# TELEPRINTER LINE POWER ARRANGEMENT FOR D.C. MAINS. TG(L)1020

80V+80V SUPPLY DERIVED FROM CONVERTER, ROTARY No.3. or 4.

7-4-36

WIRING OF MARK III PATTERN.

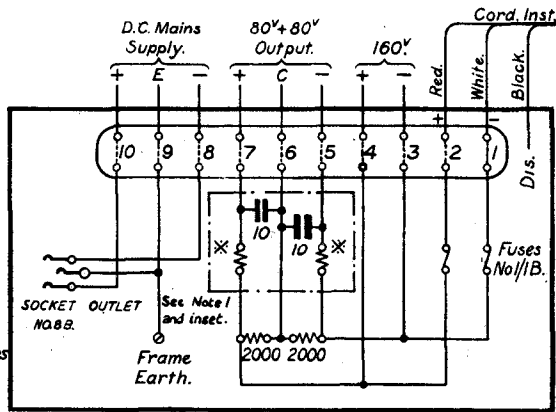
Amendment	NOTE 1 ADDED.	6-10-41	D
CONVERTER, ROTARY, NO. 4 ADDED.	16-4-37	A	Inset for Mark III added.
L.L. AND W.A. CHANGED	7-5-41	B	
PLUG & SOCKET NOMENCLATURE CHANGED	6-10-41	C
